FOUNDATION INVESTIGATION REPORT
For

Proposed Crossing at the Realigned
Welland Co. Rd. #11 (East Main St.)
Proposed Canadian National Railway
Crowland Township - Welland County
District No. 4 (Hamilton)
W.J. 68-F-74-1 -- W.P. 240-66-4

C.R.R. Overhead Bridge
East Main Street Relocation
Site 34-238
W.P. 240-66-84, W.J. 66-2-74

We have reviewed the Preliminary Bridge Drawing D-6653-P for the above structure and have the following comments to offer:

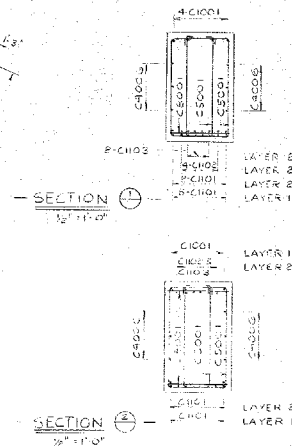
Upon the xerox, we have marked in red pencil a few spot elevations as designed, and in green pencil corresponding spot elevations as we have measured on May 26, 1969. Our measurements are based on B.M 613.81 - top of painted nut mounted on bolt of hydro tower 227 feet left of Station 60+97, East Main Extension, as established by the Department.

FOUNDATION LAYOUT & PIER DETAILS

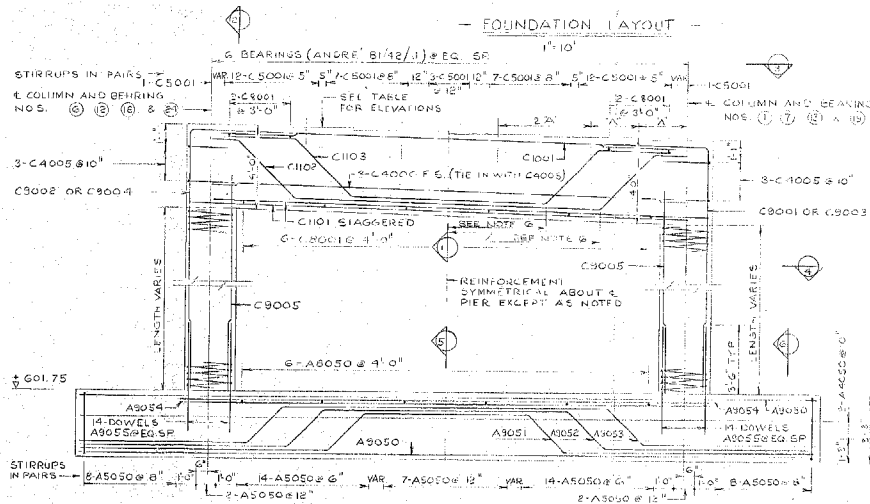
We have reviewed the final bridge drawings and submit the following comments:

The final drawings indicate piled foundations for abutment support instead of spread footings on compacted granular fills. We believe this scheme is more economical than constructing fills consisting of granular material; if this is so, the timber piles should not be driven any deeper than elev. 350.0. A note to this effect should be made on the Contract drawings.
